A ROADRUNNER CONVENIENCE STORE SITE PLAN

ROADRUNNER CONVENIENCE STORE 87-6015-14

CONVERT FROM
TOTAL PETROLEUM
TO DIAMOND SHAMROCK

CASE NUMBER
1987-6015-04

APR 15 1987 PAGE 1 OF 2 PAGES
SITE PLAN
SCALE 1"=10'-0"

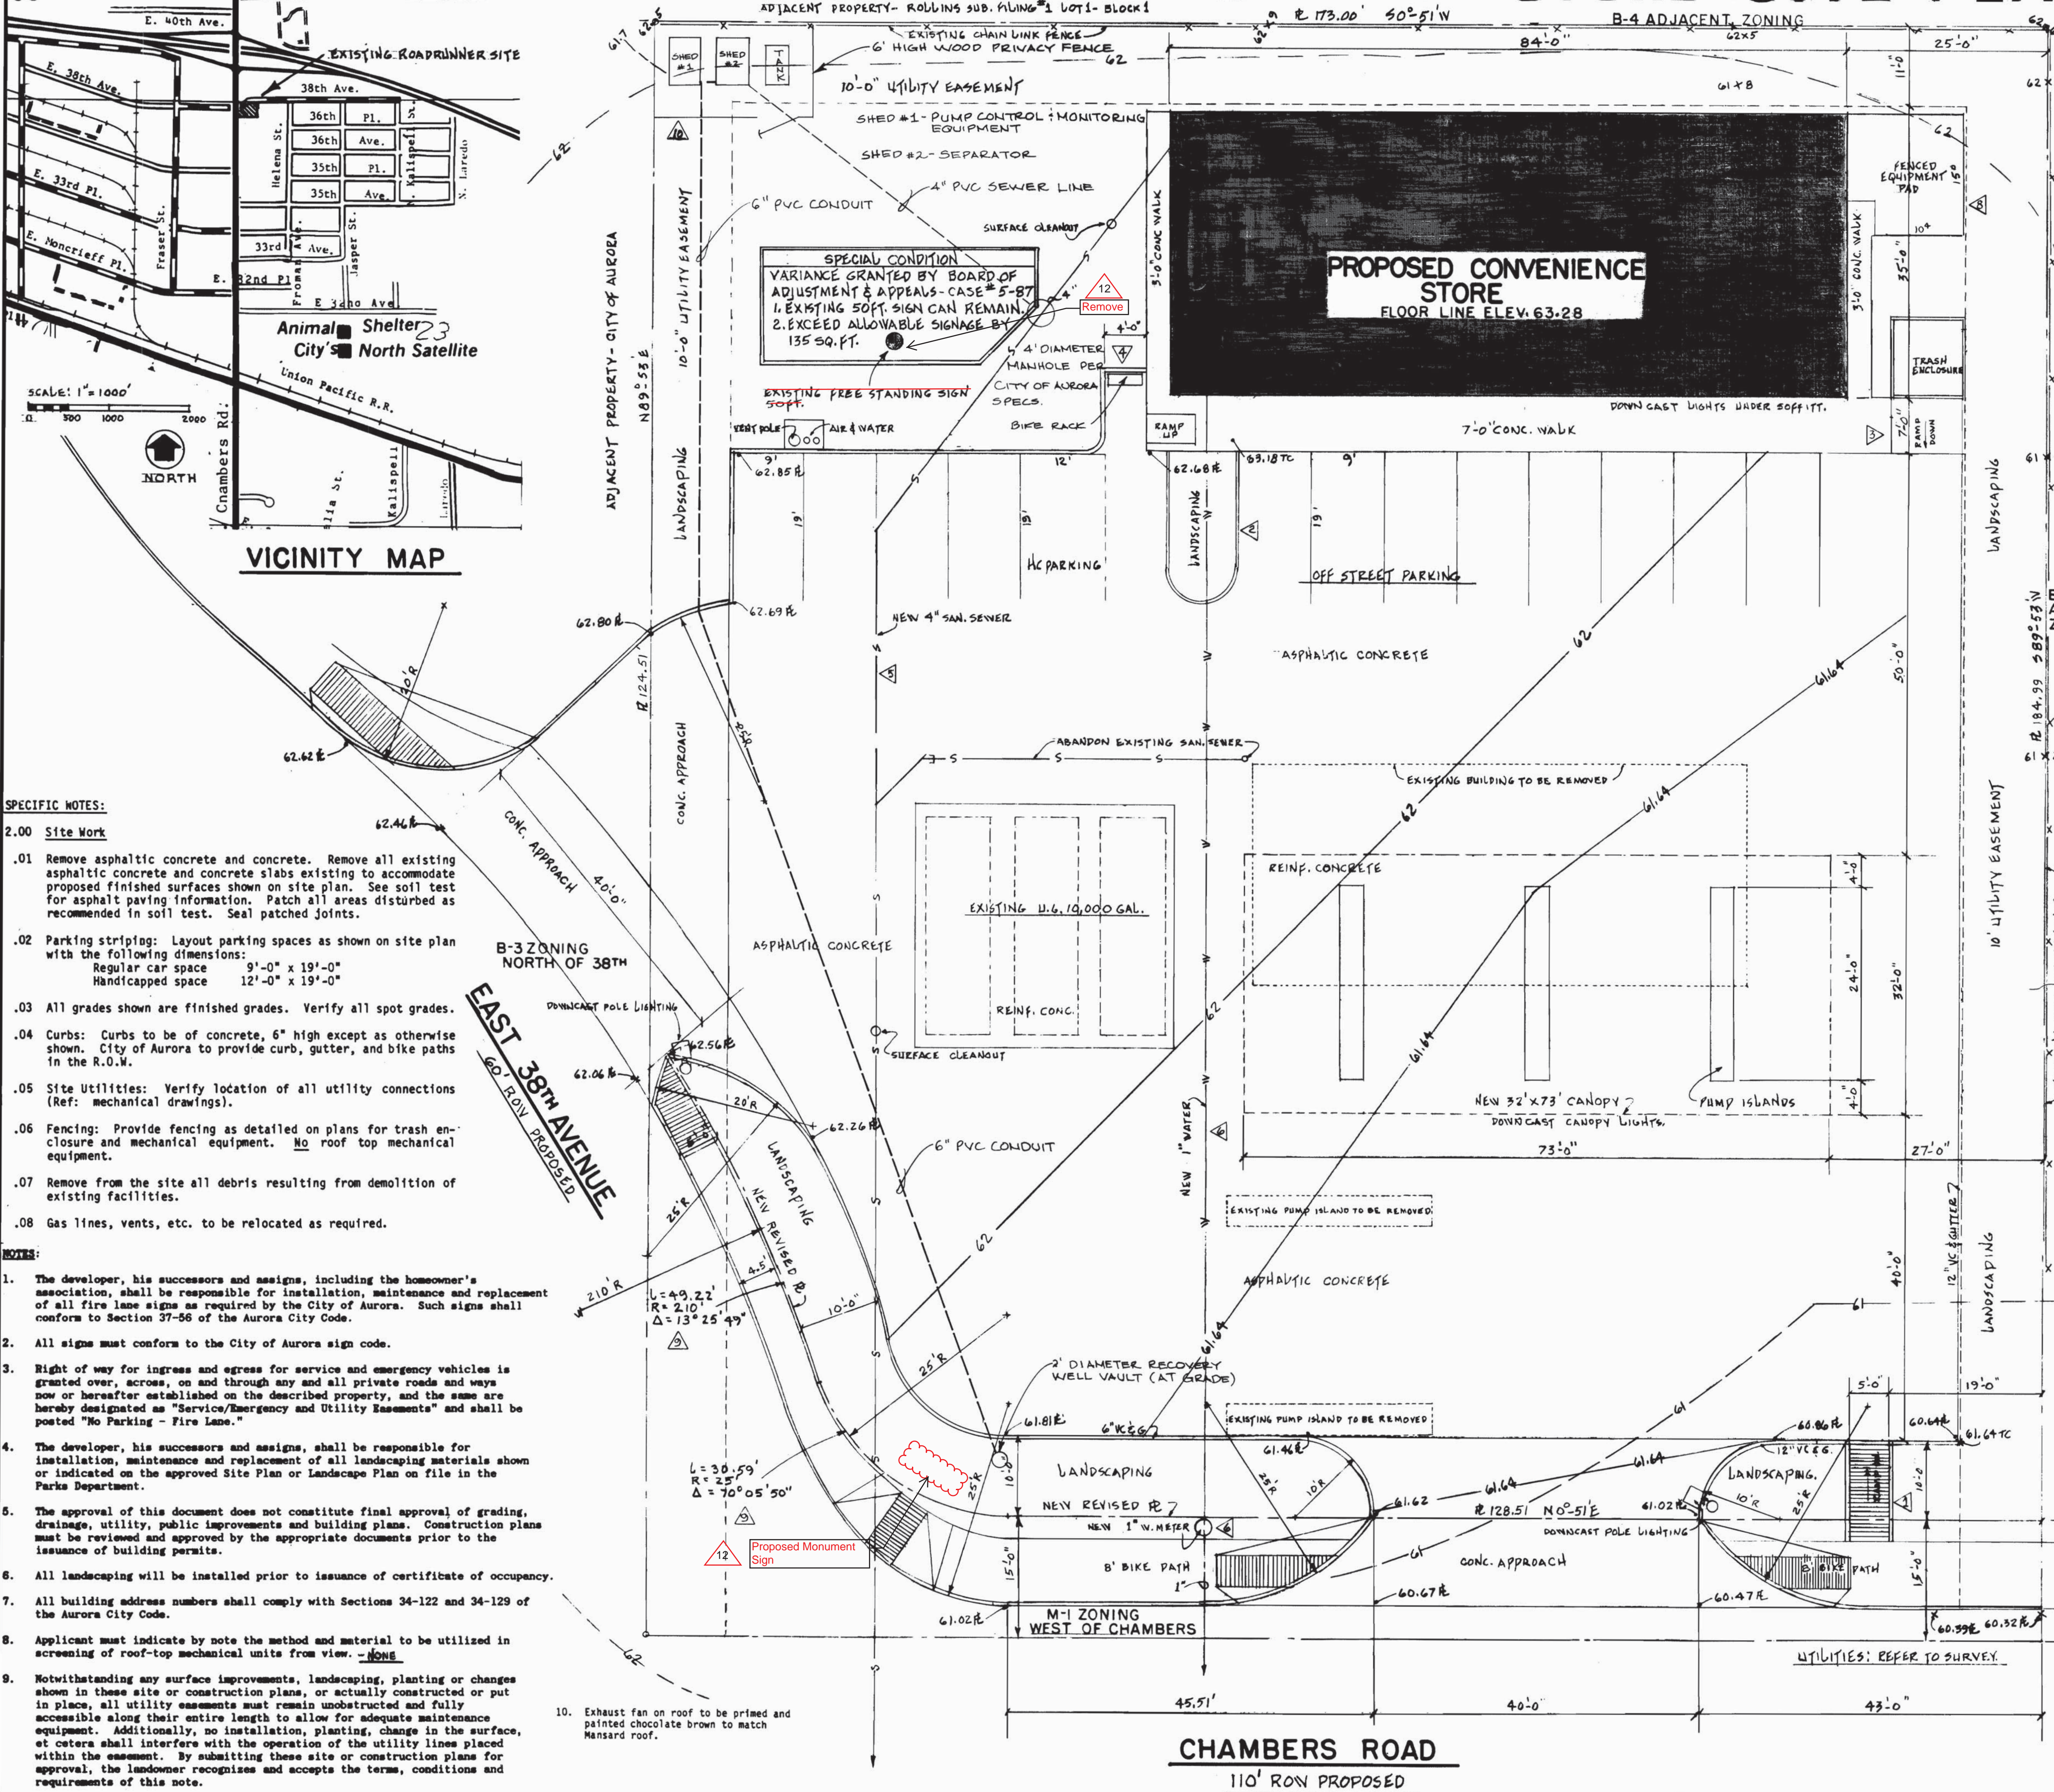
ADMINISTRATIVE AMENDMENT 9-19-90
10 ADD GROUND WATER RECOVERY AND TREATMENT SYSTEM AT NW CORNER OF SITE WITH 6' HIGH WOOD SCREEN FENCE ON 3 SIDES.

11 ADMINISTRATIVE AMENDMENT
7/14/02. BANNING FROM TOTAL TO DIAMOND SHAMROCK. SEE PAGES TO LOGGED 87-6015-4.
12 MAY 05-08-06 REBRAND FROM DIAMOND TO VALERO SEE SHEET 3790 CHAMBERS ROAD, AURORA, CO. A 4.1

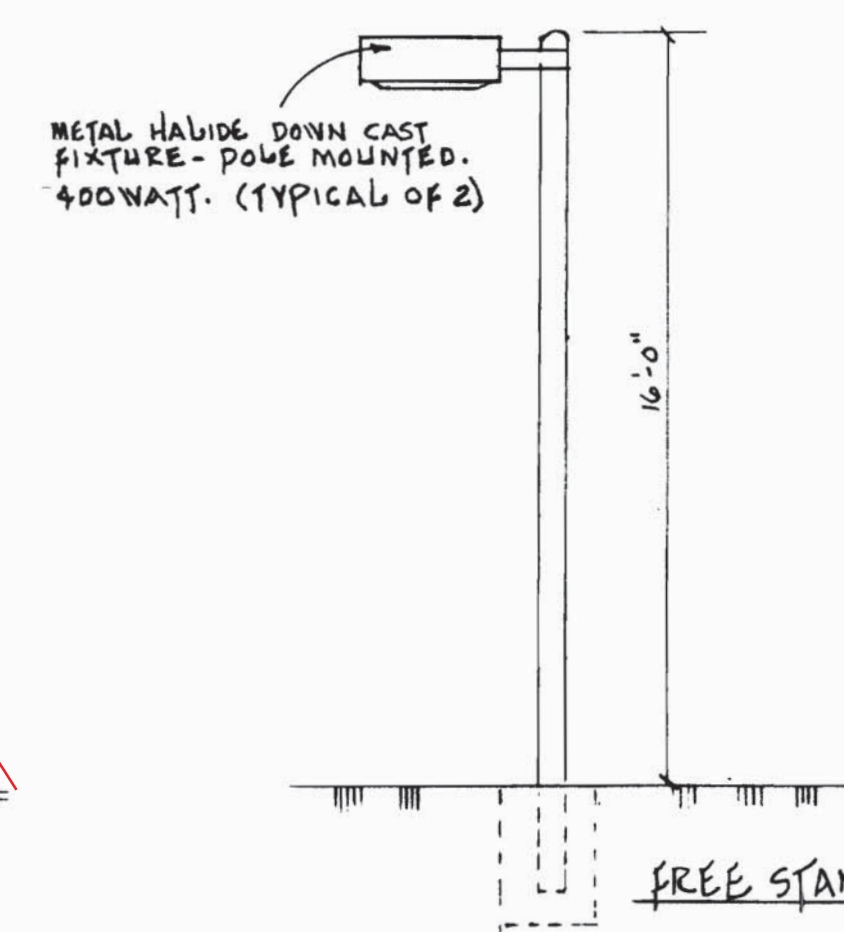
ADMIN AMEND 7/17/02
COPY TO BE CHANGED TO
DIAMOND SHAM ROLL.
GIVEN VARIANCE IN 1998, NOT
PART OF TOTAL SIGN ALLOWANCE.

LANDSCAPE DEVELOPMENT PLAN FOR A

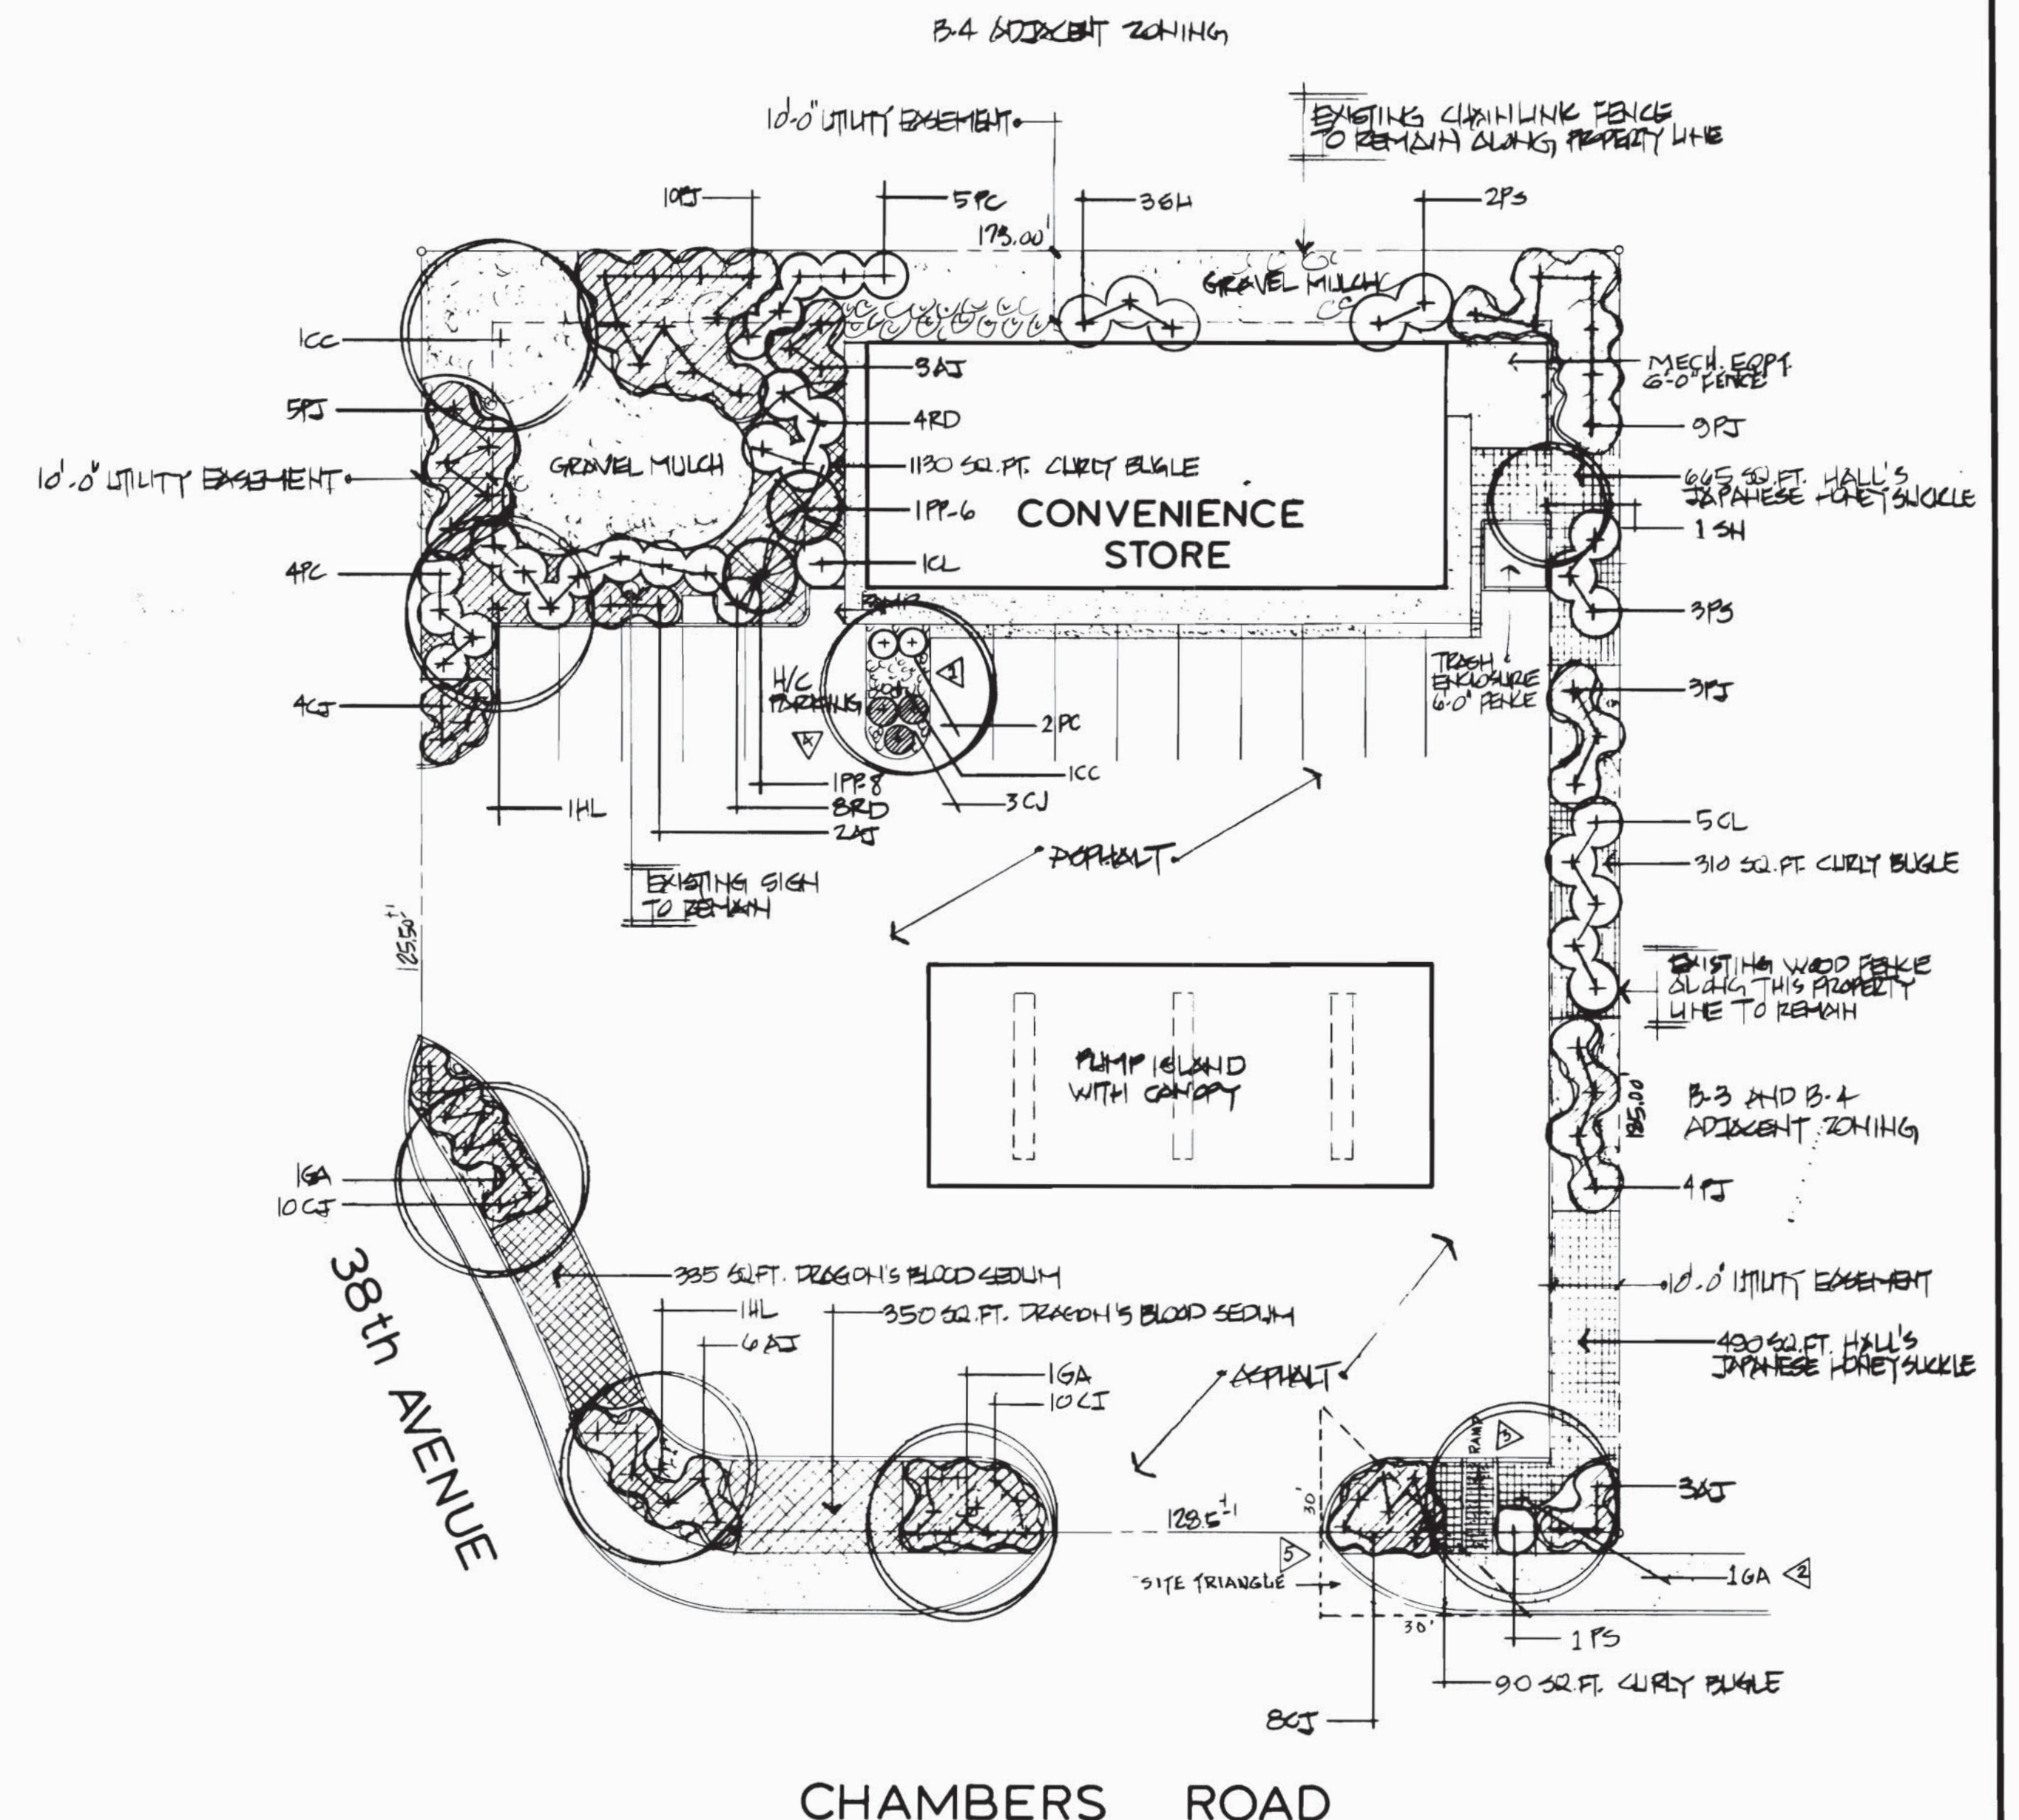
MAY 4, 1987
 ① LANDSCAPED ISLAND
 ADDED
 ② TREE MOVED DUE TO
SITE TRIANGLE
 ③ WALK RAMP ADDED
 MAY 15, 1987
 ④ 1 CC ADDED
 ⑤ SITE TRIANGLE ADDED
